CENTRAL VALLEY FLOOD MANAGEMENT PLANNING PROGRAM

Errata to the Public Draft

2012 Central Valley Flood Protection Plan

Volume II – Attachment 7

11. Attachment 7 – Plan Formulation Report, Section 7.1.3, Figure 7-1, page 7-8

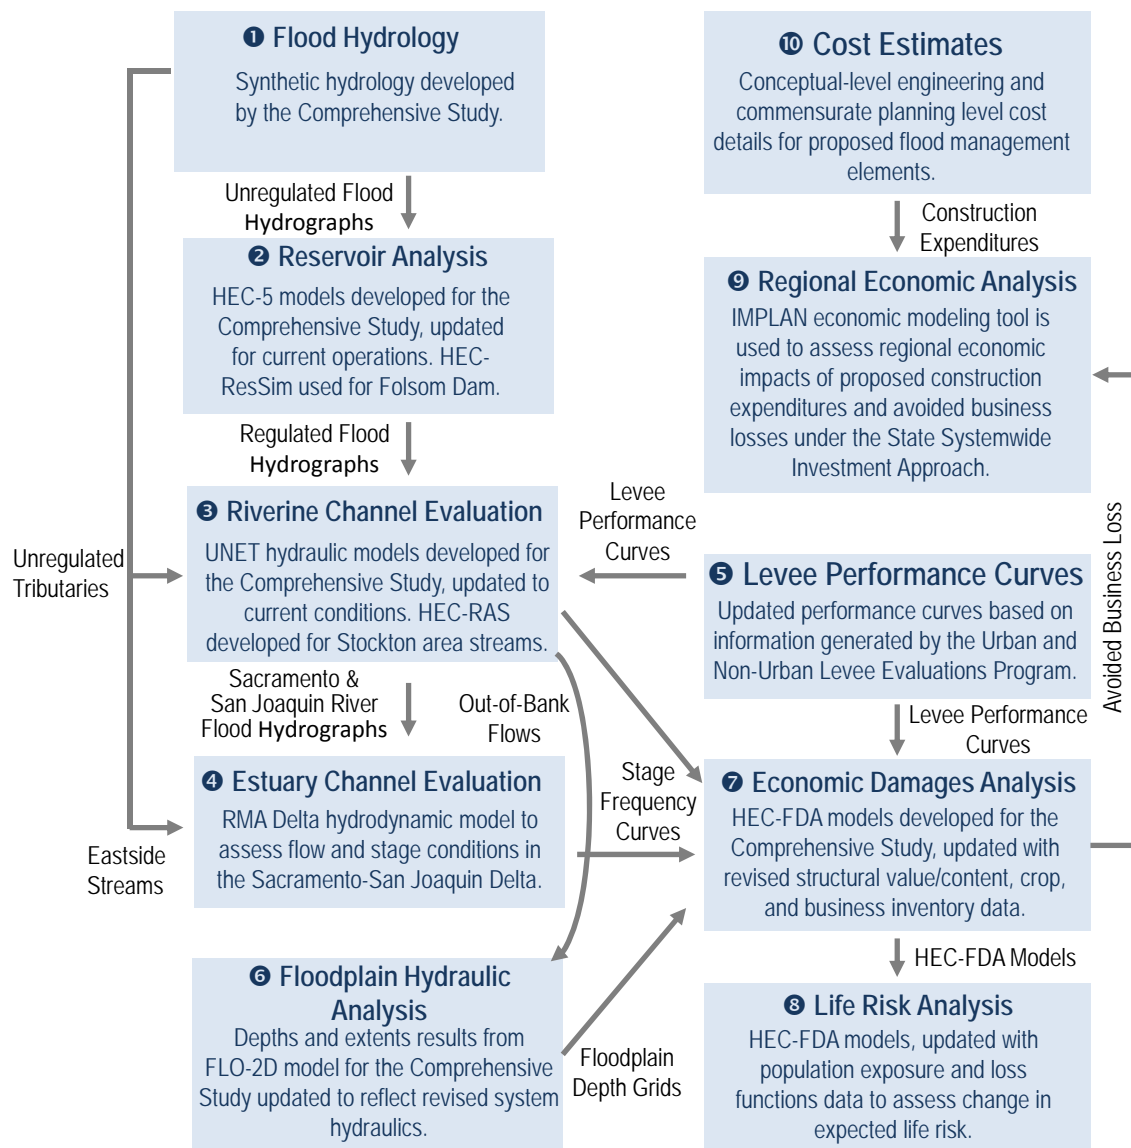
Replace Figure 7-1 “Technical Analyses and Tools Supporting 2012 CVFPP Development” with the following for color consistency:

16. Attachment 7 – Plan Formulation Report, Section 7.3.4, page 7-29, figures 7-12 and 7-13

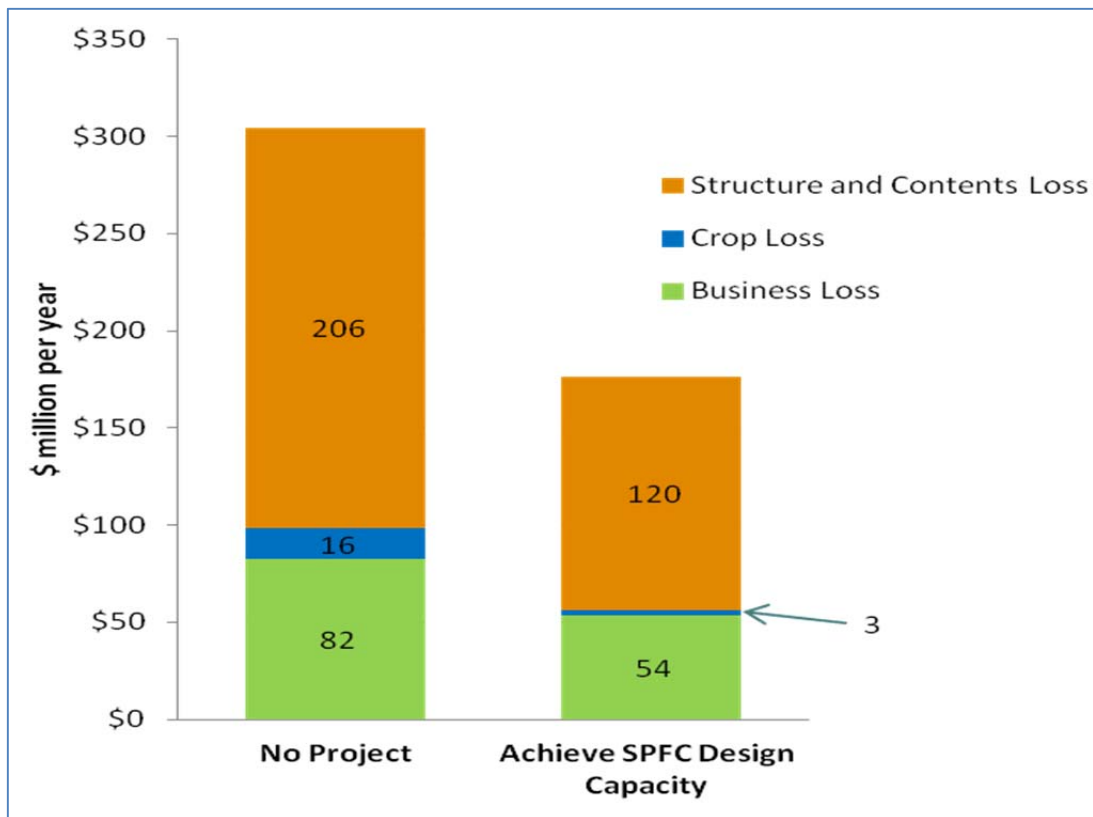
Replace Figure 7-12 “Expected Annual Damages from Flooding: Achieve State Plan of Flood Control Design Flow Capacity Approach Compared to No Project for the Sacramento Basin” with the following:

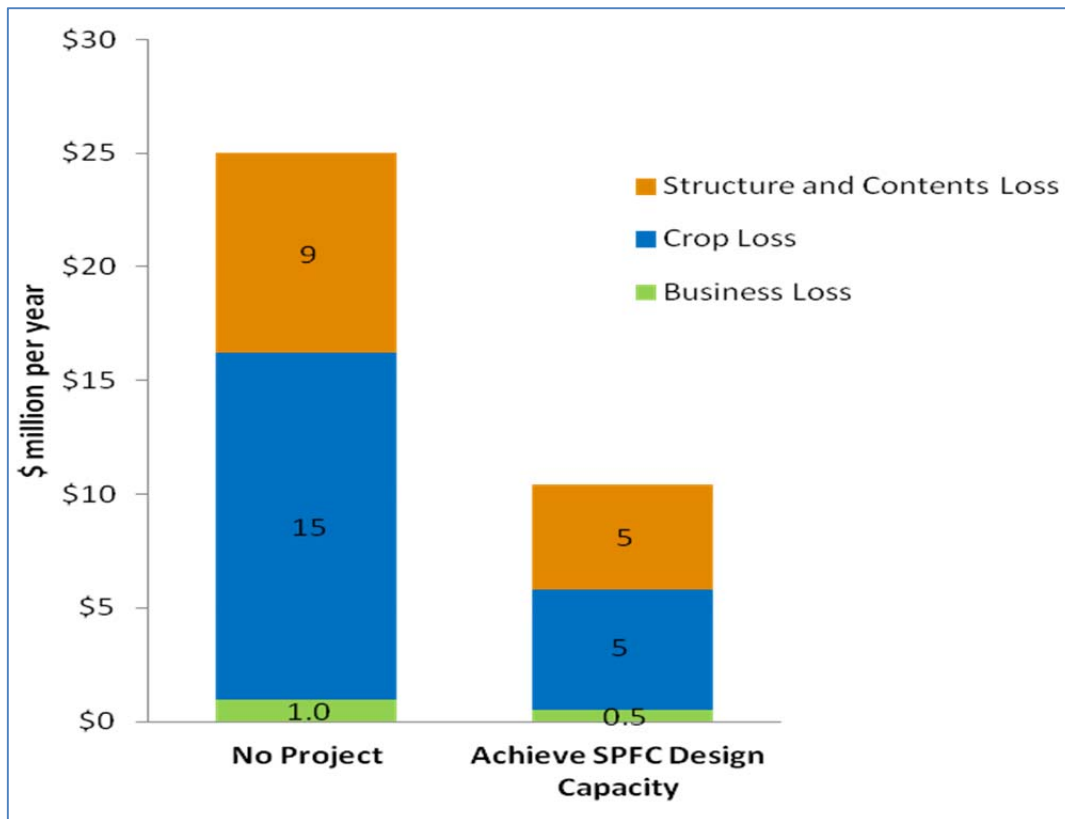
Replace Figure 7-13 “Expected Annual Damages from Flooding: Achieve State Plan of Flood Control Design Flow Capacity Approach Compared to No Project for the San Joaquin Basin” with the following:

18. Attachment 7 – Plan Formulation Report, Section 7.4.4, page 7-51, figures 7-21 and 7-22

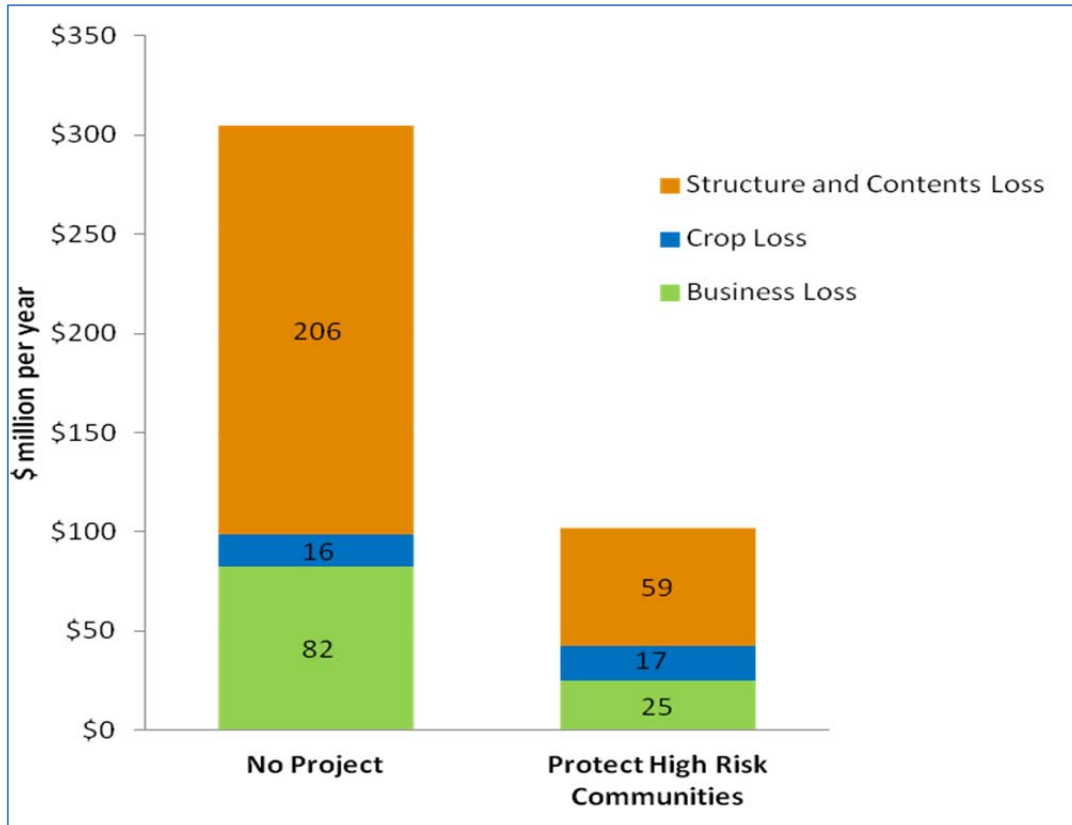
Replace Figure 7-21 “Expected Annual Damages from Flooding: Protect High Risk Communities Approach Compared to No Project for the Sacramento Basin” with the following:

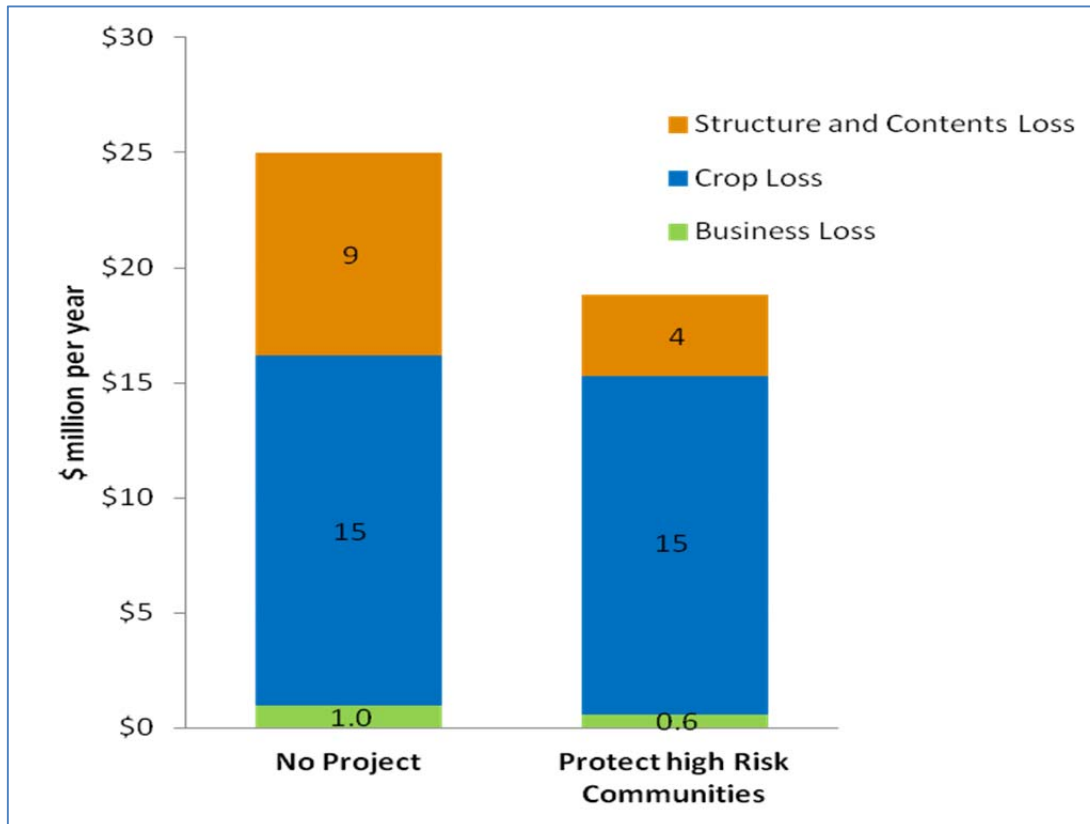
Replace Figure 7-22 “Expected Annual Damages from Flooding: Protect High Risk Communities Approach Compared to No Project for the San Joaquin Basin” with the following:

21. Attachment 7 – Plan Formulation Report, Section 7.5.3, Page 7-62

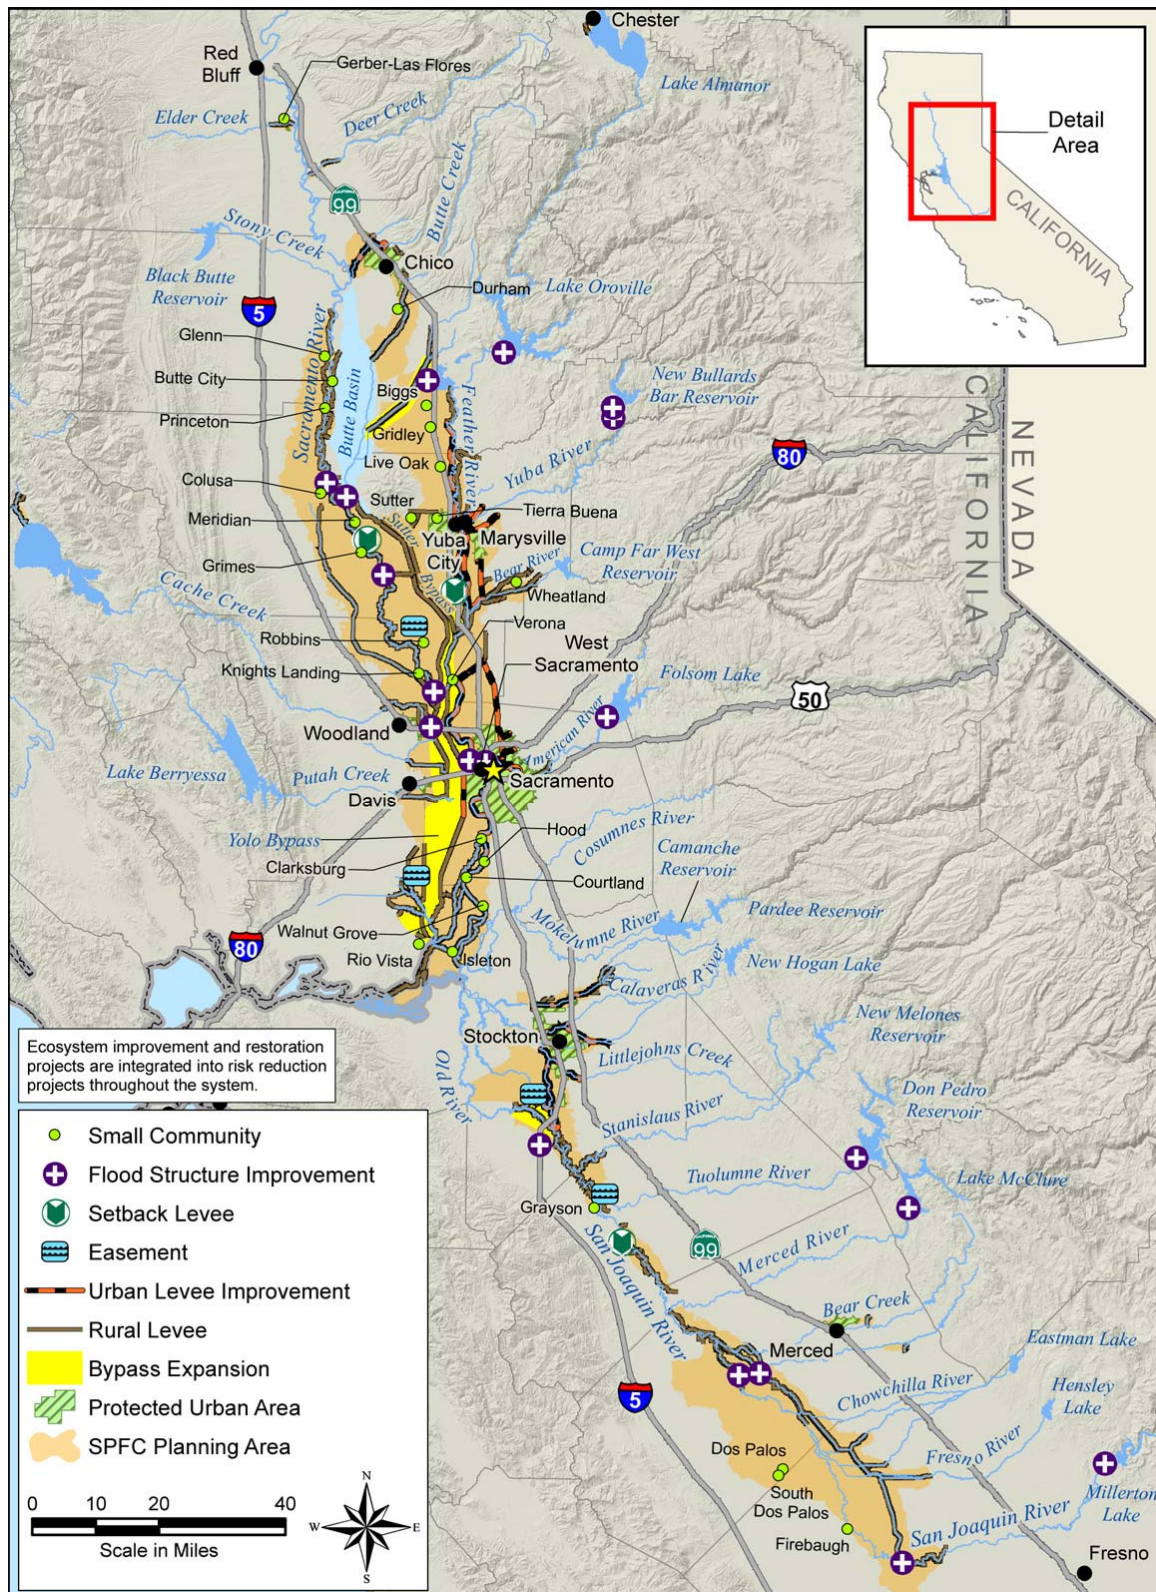
Figure 7-25 “Improvements Included in Enhance Flood System Capacity Approach” is replaced by the following:

22. Attachment 7 – Plan Formulation Report, Section 7.5.4, page 7-67, figures 7-28 and 7-29

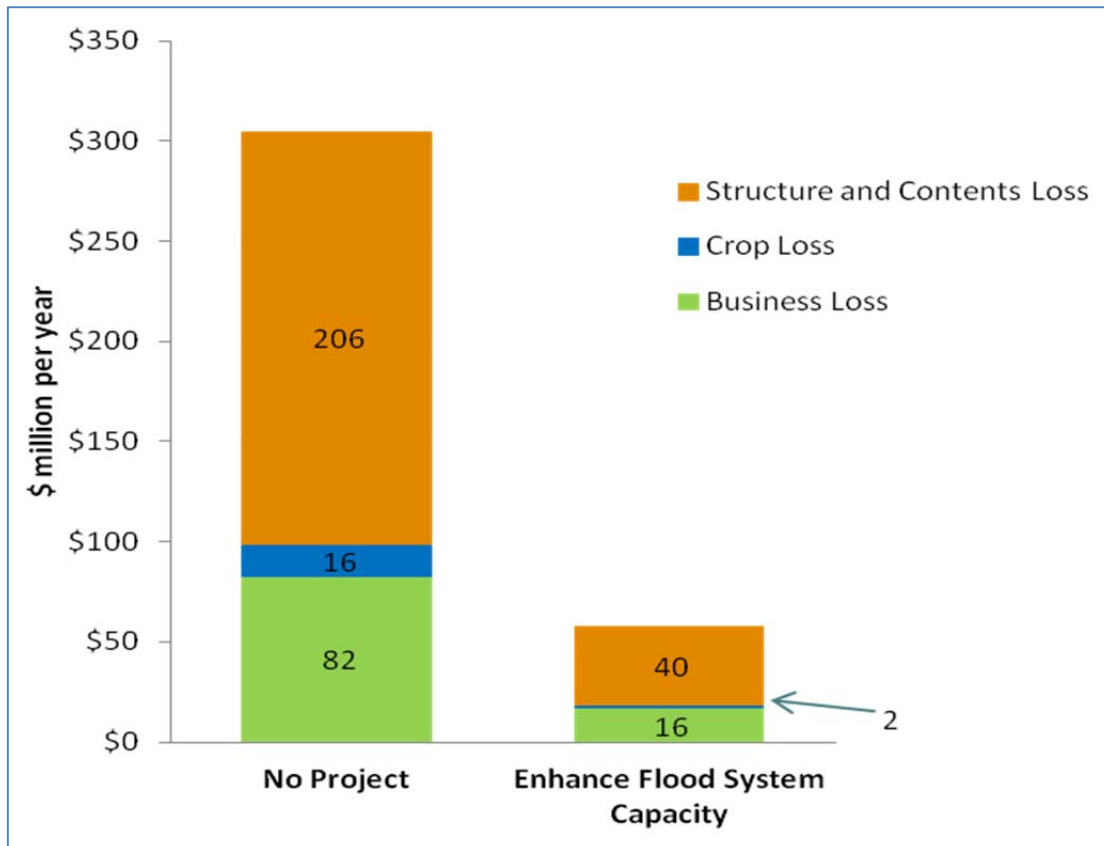
Replace Figure 7-28 “Expected Annual Damages from Flooding: Enhance Flood System Capacity Approach Compared to No Project for the Sacramento Basin” with the following:

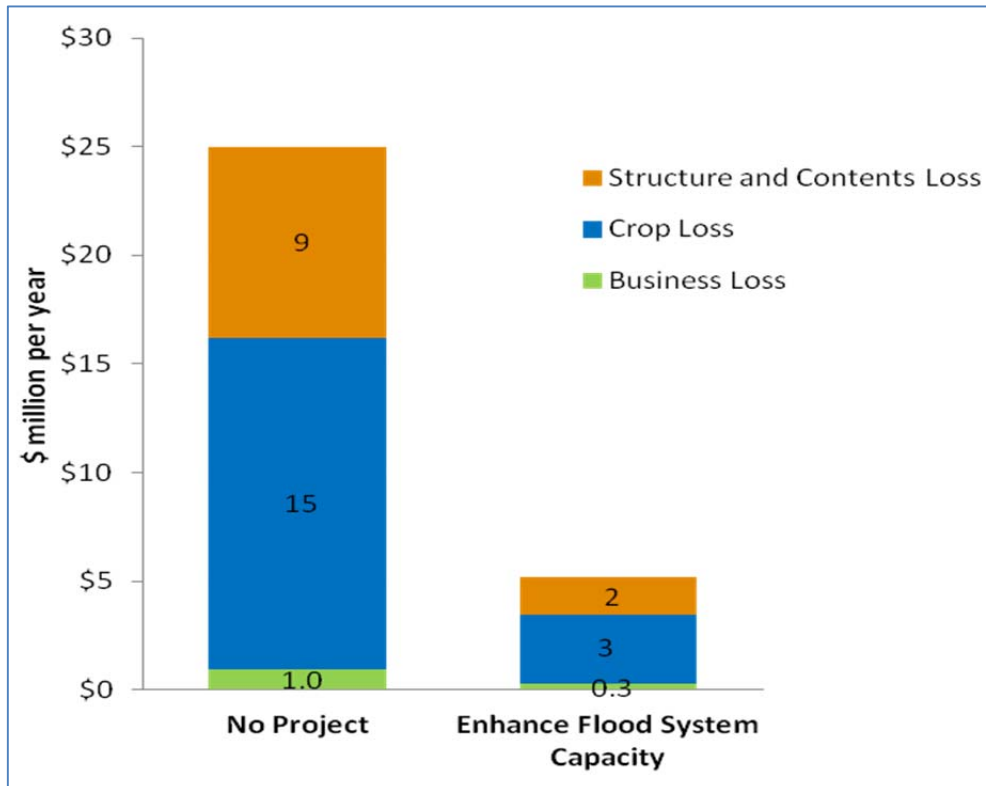
Replace Figure 7-29 “Expected Annual Damages from Flooding: Enhance Flood System Capacity Approach Compared to No Project for the San Joaquin Basin” with the following:

24. Attachment 7 – Plan Formulation Report, Section 7.6.2, pages 7-75 and 7-76, figures 7-32 and 7-33

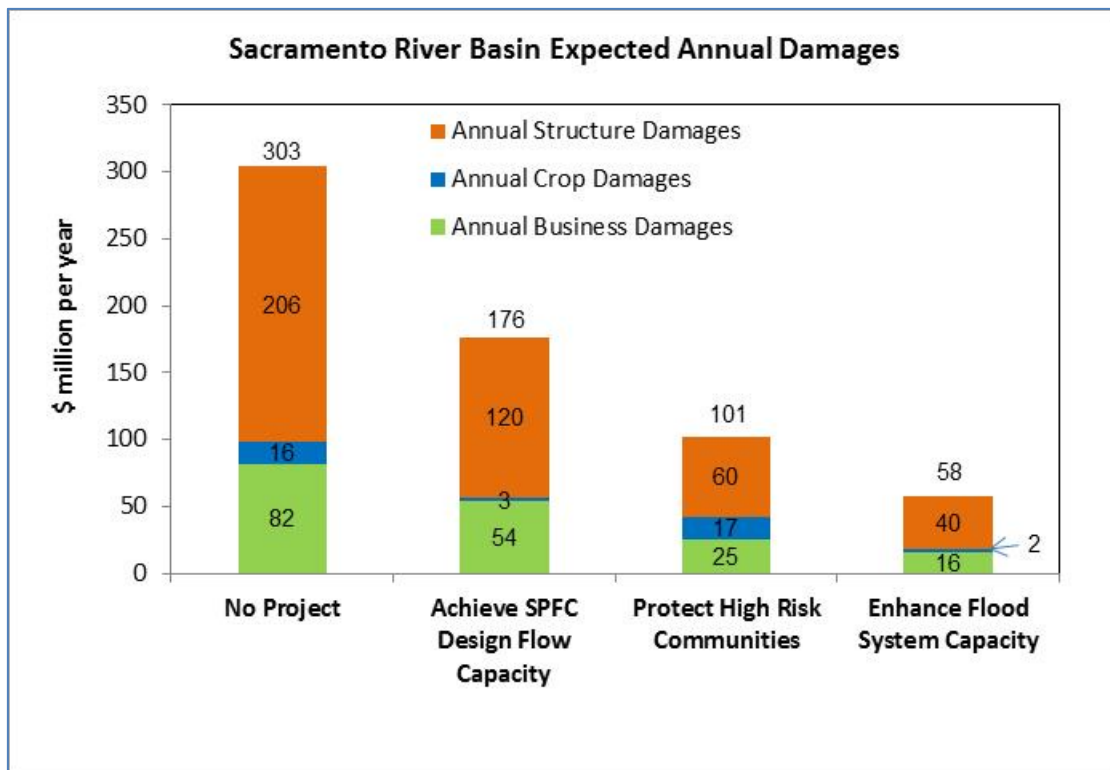
Replace Figure 7-32 “Summary of Potential Annual Direct Impacts of Flooding in the Sacramento River Basin” with the following:

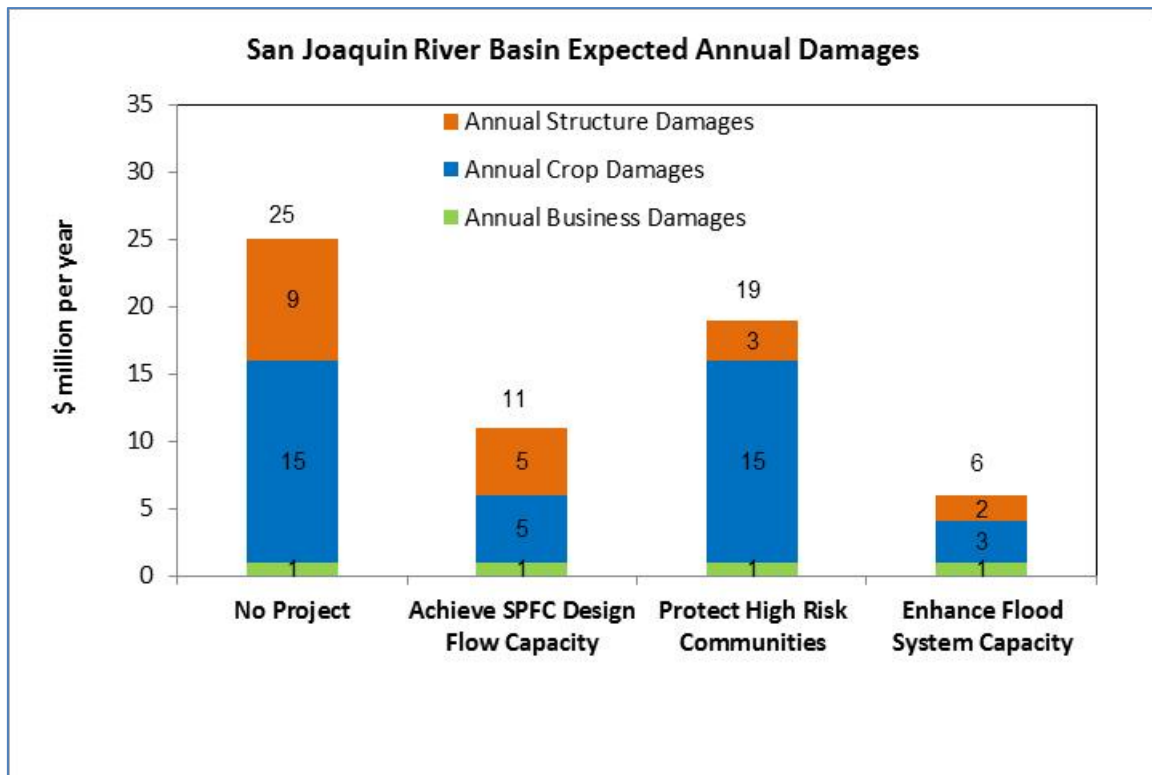
Replace Figure 7-33 “Summary of Potential Annual Direct Impacts of Flooding in the San Joaquin River Basin” with the following:
